**Re: wpd Fairview Wind Incorporated
EB-2014-0226**

WPD FAIRVIEW WIND INCORPORATED'S (THE "APPLICANT") RESPONSE TO BOARD STAFF INTERROGATORIES

THE APPLICANT'S RESPONSE TO THE TOWNSHIP OF CLEARVIEW'S INTERROGATORIES

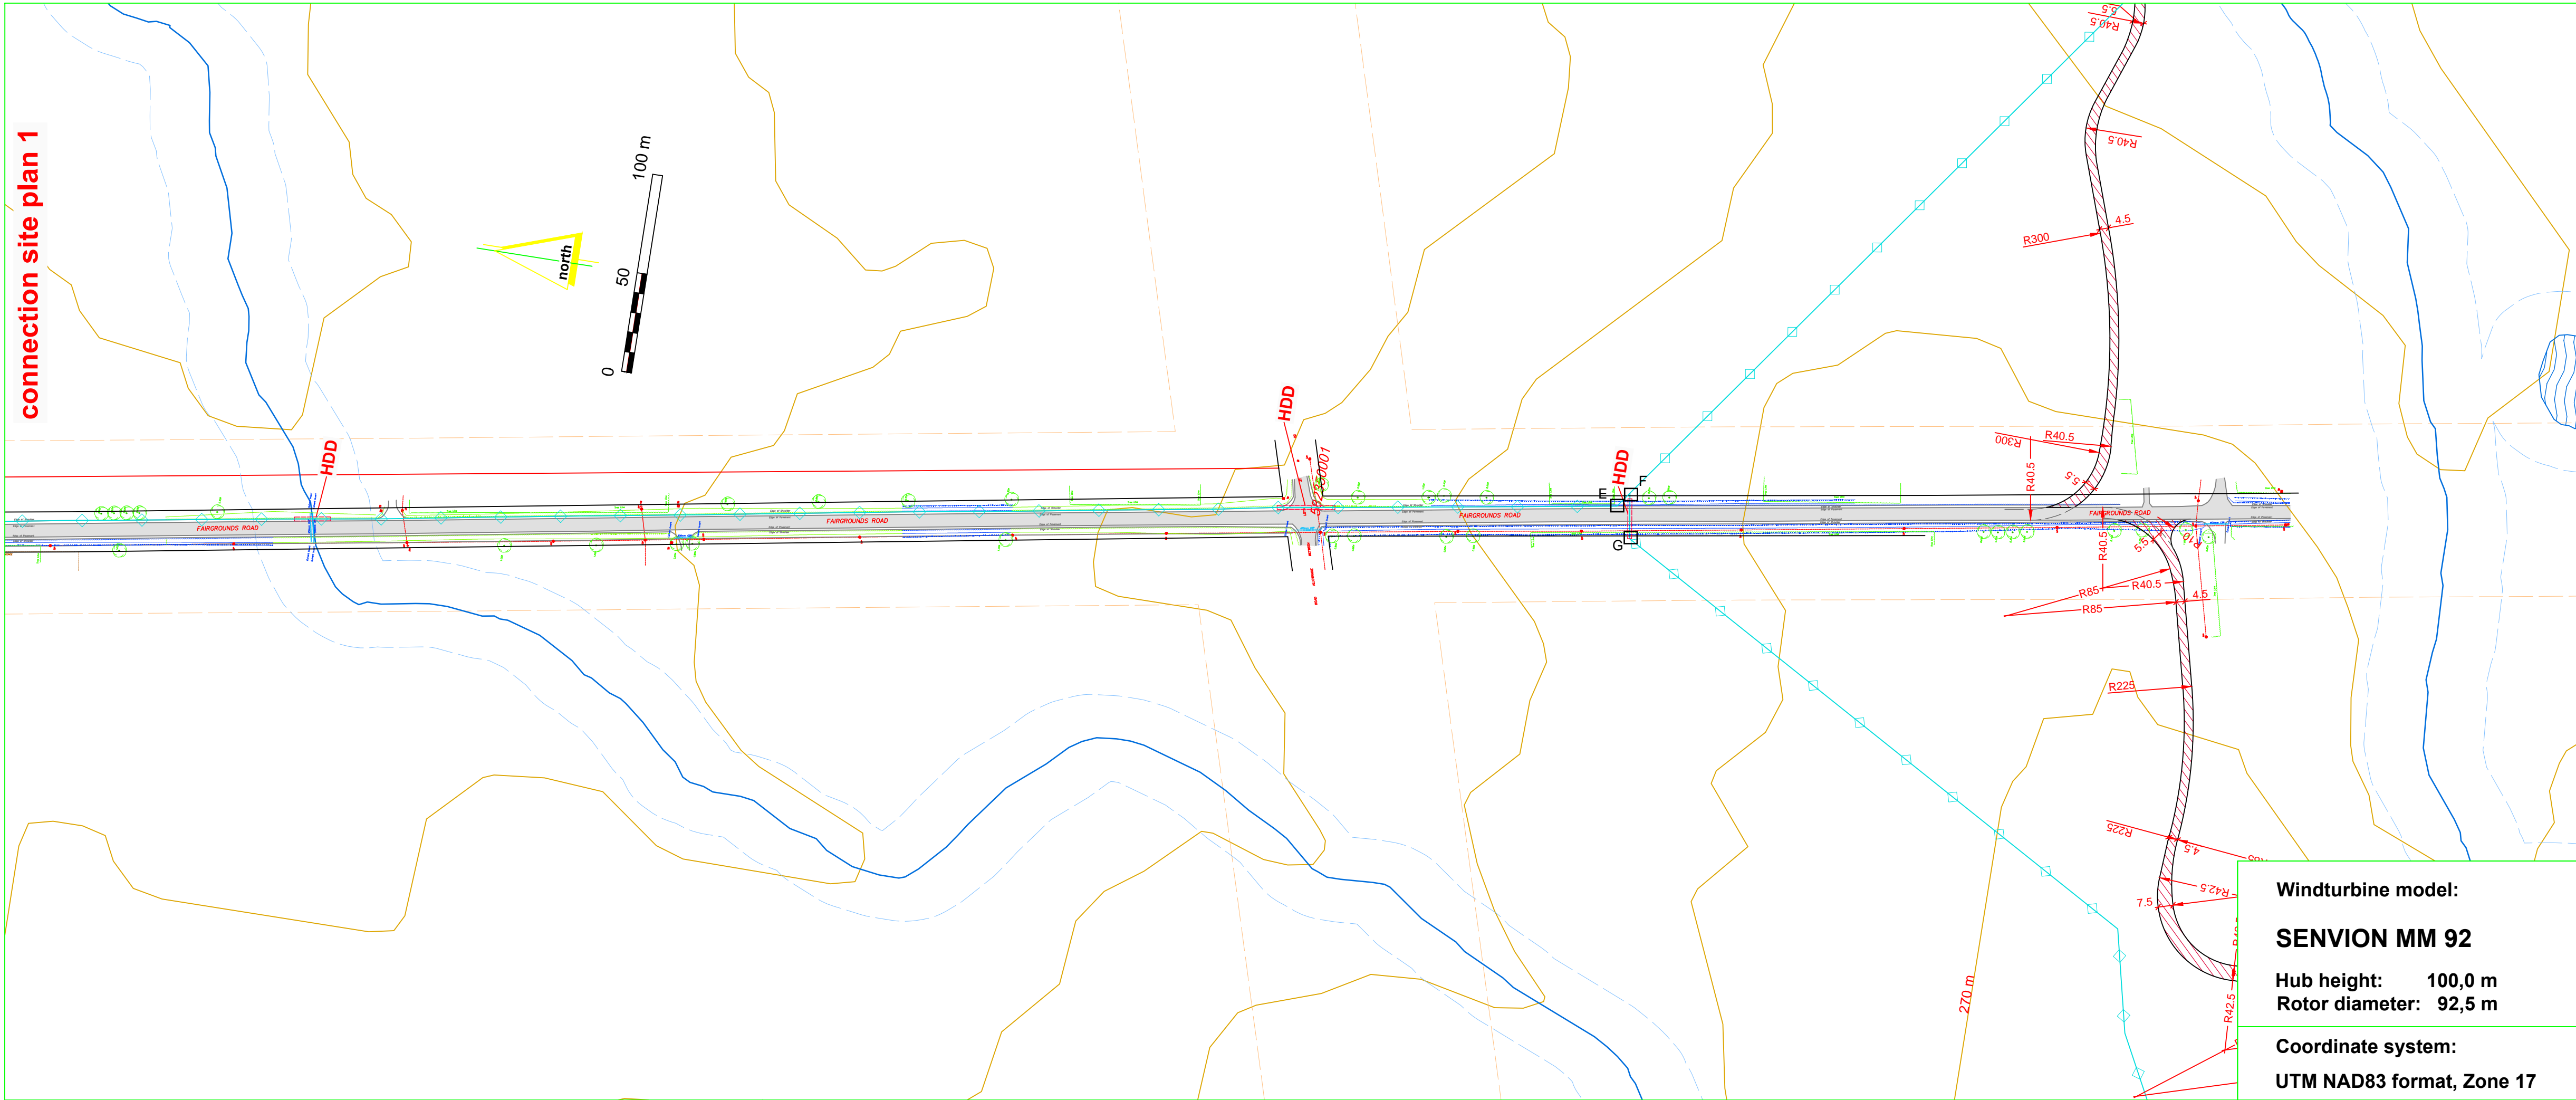
- 19 b) Also, please provide an expanded listing of the Road Allowances as
20 requested in the previous question, with an additional column to indicate the
21 positioning of the underground distribution within the roadway, within a 2
22 metre range e.g. "2 - 4 m from the east edge of the roadway". Provide
23 additional rows in the table where required because of changes in the
24 position of the line within the roadway, such as where it crosses to the other
25 side of the Roadway Allowance. This positioning should reflect the Concept
26 Drawing Site Plans provided in reference d) (tab C1.2B of the application) as
27 preliminary drawings. Please indicate where there are changes from the
28 preliminary drawing.

- a) Please refer to Appendix "A" attached hereto.
- b) Please refer to Appendixes "A" through "D" attached hereto.
- c) The Applicant provided the Township with the planned distribution route for the Fairgrounds Collector Line. However, because the Township refused to meet with the Applicant, the Township does not have the level of detail for the distribution route that was provided to the Ontario Energy Board (the "Board") in this Application.

Fairview – Locates Along Fairgrounds Rd – Map 1

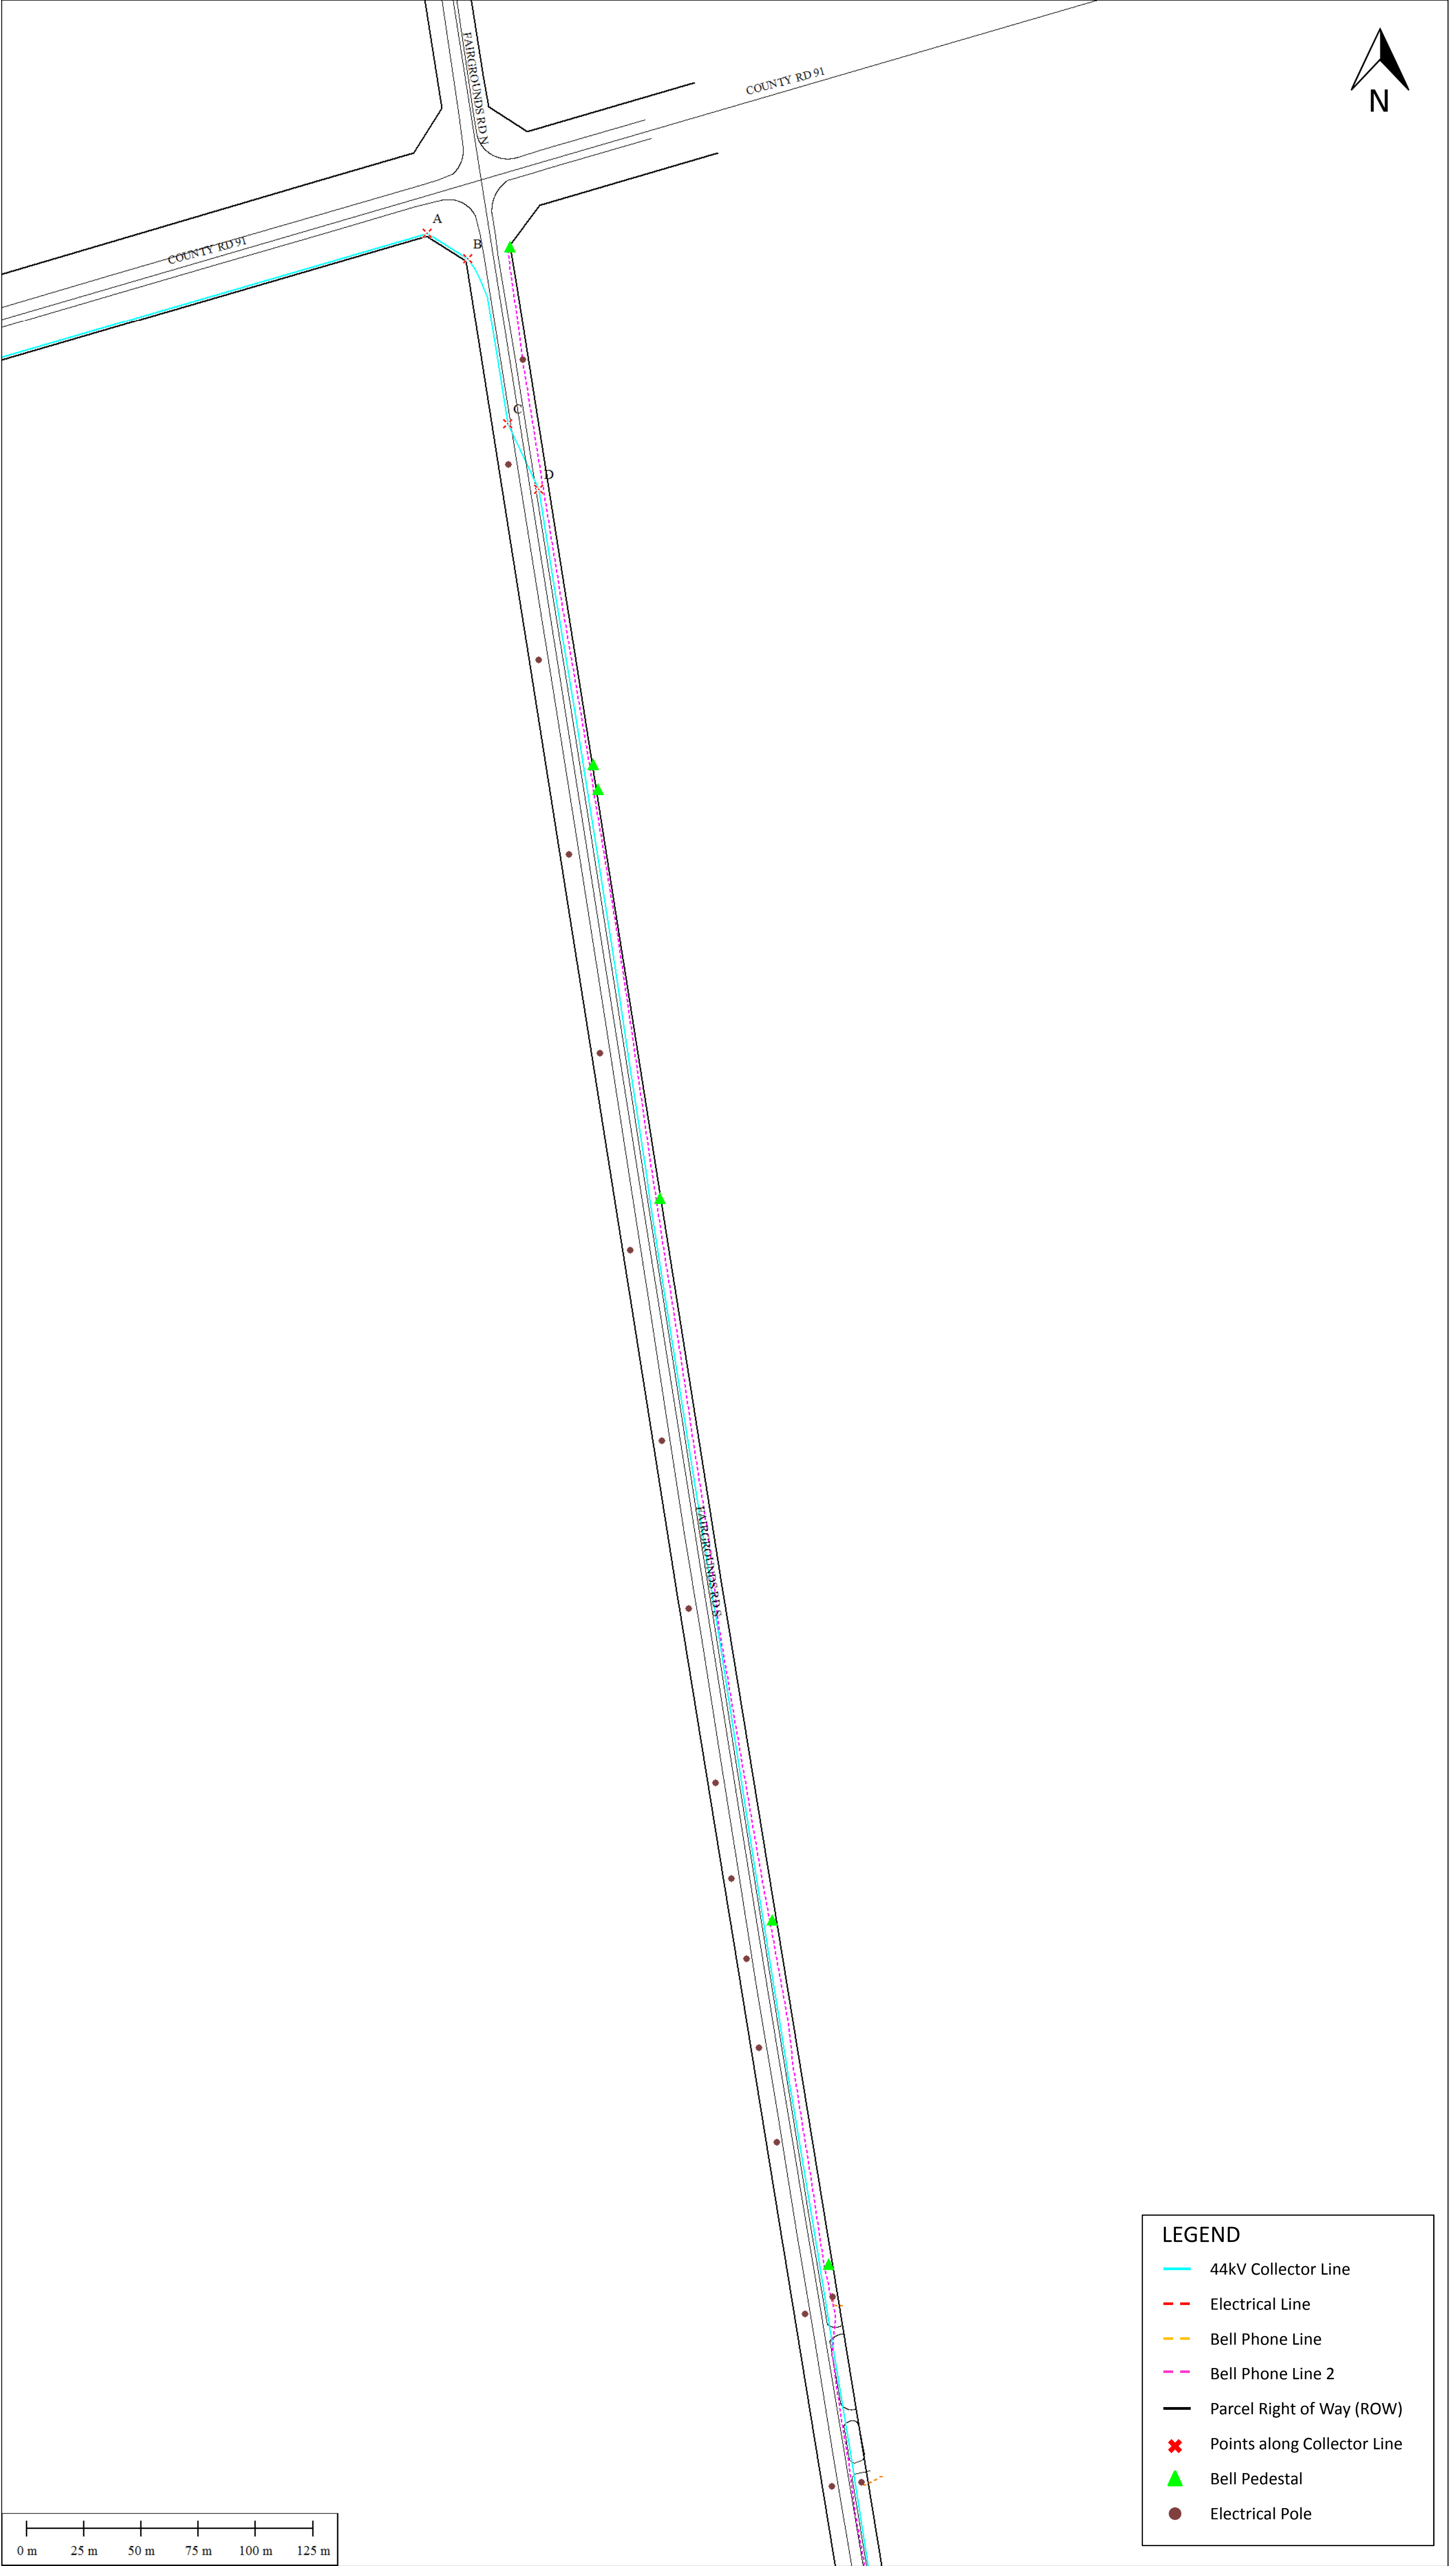
- d) Has Fairview located utilities and other obstacles which have to be avoided along the route of the Fairgrounds Collector Line?
- e) What construction methods does Fairview propose to use to ensure integrity of other utilities in the roadway is not affected?

- d) The Applicant has determined that Bell and HONI distribution poles are located along the route of the Fairgrounds Collector Line. Maps showing the location of the Bell and HONI distribution poles relative to the route of the Fairgrounds Collector Line are attached hereto as Appendixes "E" and "F". Attached at Appendix "G" are locate studies showing the location of the Fairgrounds Collector Line in relation to HONI's infrastructure located on Fairgrounds Road.
